Subject: 31036-A3-NW Bicester-APPLICATION REF. 21/01630/OUT-Amendments to the Development Parameters

## Land at North West Bicester

## **Development Parameters Schedule** and Plans

## **APPLICATION REF. 21/01630/OUT** <u>LAND AT NORTH WEST BICESTER - ON BEHALF OF FIRETHORN DEVELOPMENTS LTD</u>

Development Parameter Plan 1: Maximum building heights and footprint

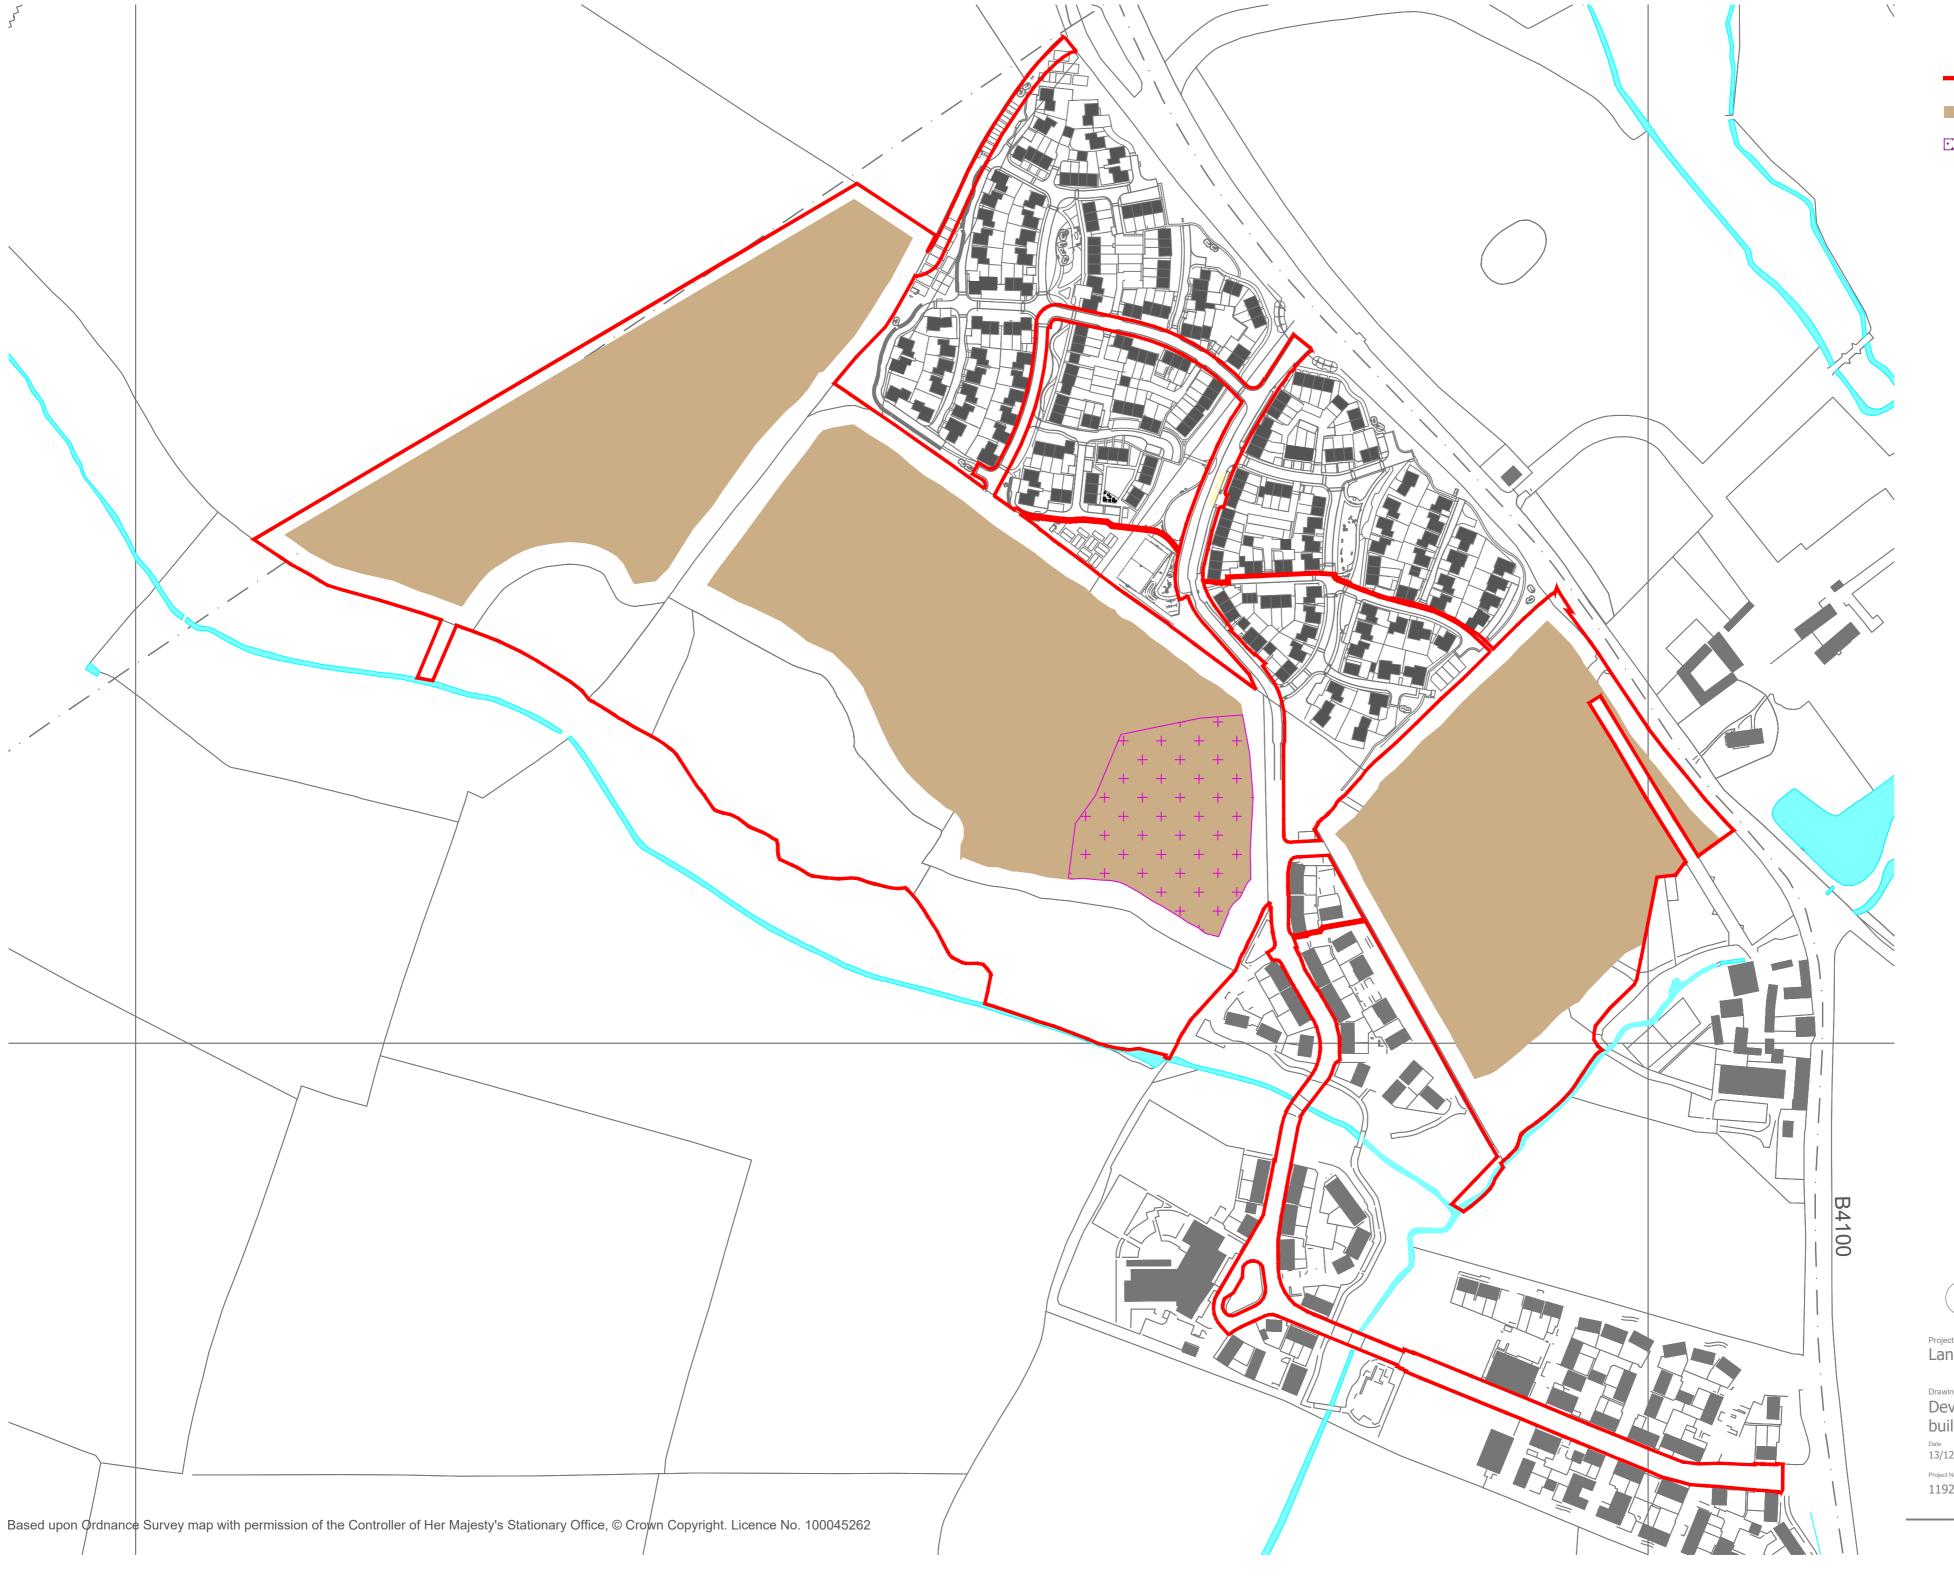
The nature of Parameter Plans is such that there are often areas of overlap at the outline stage of a proposal to allow flexibility for the development's build out during the reserved matters stages. However, it is acknowledged that the areas shown on the Green Space Parameter Plan will not be built on and therefore, to simplify the plans, the Built Footprint Plan has also been amended to reflect that. This has resulted in some minor amendments to the Parameters text to add clarity around this, but please note that the Access and Movement Plan has not changed – we have simply included its existing revision number for absolute clarity.

Following further consultation comments from CDC, a revision to the presentation of information on the Parameter Plans has been undertaken. The revision encompasses removing built development from areas where greenspace has been assessed in the ES. The nature of parameter plans is such that there are often areas of overlap at the outline stage of a proposal to allow flexibility for the development's build out during the reserved matters stages. However, it is acknowledged that the areas shown as greenspace on the parameter plans will not be built on and therefore, to simplify the plans, the build footprint has been amended. There are no changes to the conclusions set out in the assessments of the May 2021 ES, as updated by the ES Addenda.

Built form up to 12 metres

Built form up to at 14 metres

Development Parameter Plan 3.1C:
Maximum building heights and footprint

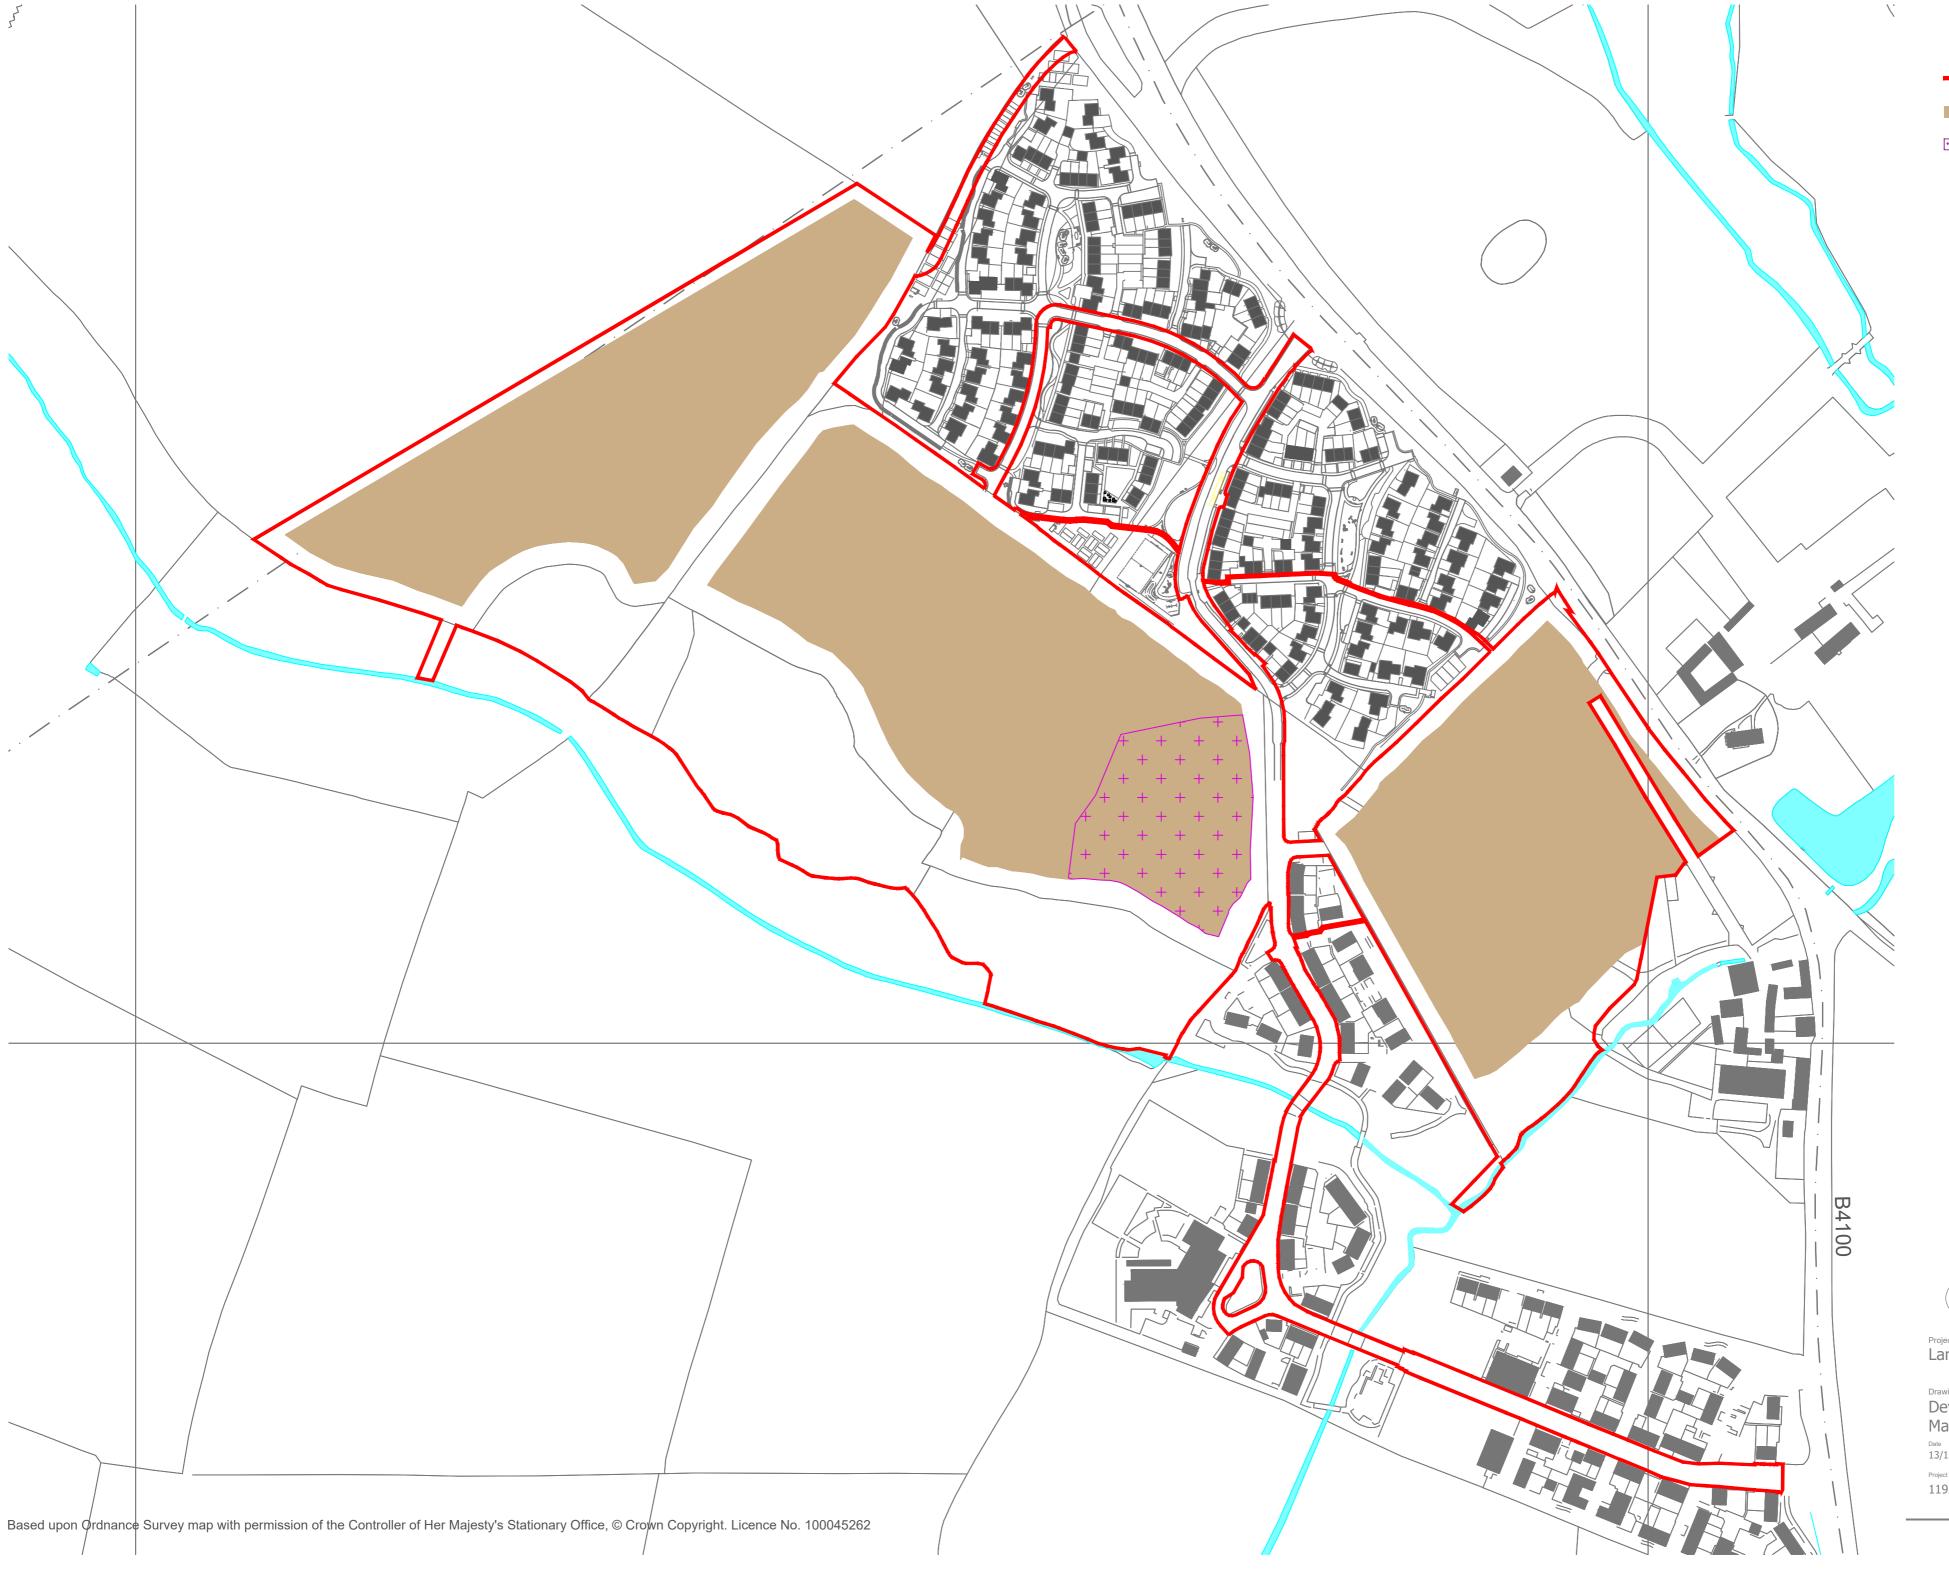
The revised Parameter Plans are appended to this letter as Figures 3.1C and 3.2B (the plans are marked with the suffix C to distinguish them from the previous amendments in previous addenda). An amended version of the Development Parameters document, containing these amended plans and minor changes to the Parameters wording to reflect these amendments, will also be submitted to you alongside the enclosed.

Built form up to 12 metres

Built form up to at 14 metres
